Public Works (1937) Department.

G.O. No. 2026

Subject.- Providing Electrical installation to the P.W.D. Sub Division Office, Mangalore- West Coast Division.

SUBJECT :— Electric Distallation - South Kanara. Mangalore. Sub-Dn office PWD. Expre. Rs 850/- Approved.

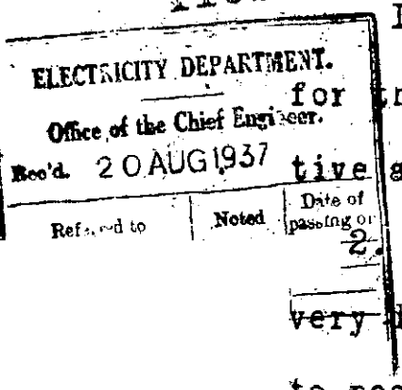
The estimate of Rs.850/- for providing the Sub-Divisional Office at Mangalore with electric installation includes a sum of Rs.575/- on account of five fans.--

(1) Sub-Divisional Officer's room ...	1	of Plan below.
(2) Clerks' room. ...	2	
(3) Section Officer's room.	2

2 Item (2) -- There seems to be no necessity to provide fans in the clerks' room. In the case of the taluk office at Palghat, no fans have been provided for clerks. Following that precedent, this Department has recently suggested that the provision of fans for clerks in the Hindupur Taluk Office may be

omitted. The two fans proposed for the clerks' room in the present case may similarly be cut out.

3 Item (3)- Submitted that one fan should be sufficient for the Section Officer. The extra fan which is apparently for his clerk may be cut out.

4 If the above suggestions are approved, the estimate will be reduced by Rs.345/- to Rs.505. Subject to these remarks, the draft order may be accepted.

Mr 2-3 anti The Finance Deptt suggestion to omit fans for clerks in the Mudigere Taluk office has been remitted to Revenue for consideration and a final decision has not yet been arrived at in this case. There are however precedents in which clerks in Taluk offices have been allowed fans. But as Mangalore is not a very hot place the Finance Deptt's suggestion may perhaps be accepted.

The C.E. has submitted estimate amounting to Rs 850/- for the provision of electric installation in the P.W.D. Sub Division Office at Mangalore S. Kanara Dt. The estimate includes provision for two fans - in the clerks room and two in the Section Officers room. The Govt. consider that fans need not be provided in ~~are not necessary for~~ the clerks' room and that one fan is sufficient for the Section Officers room. The omitting provision for three fans the Govt. approve an expenditure of Rs 500/- (Rupees five hundred only) on the work
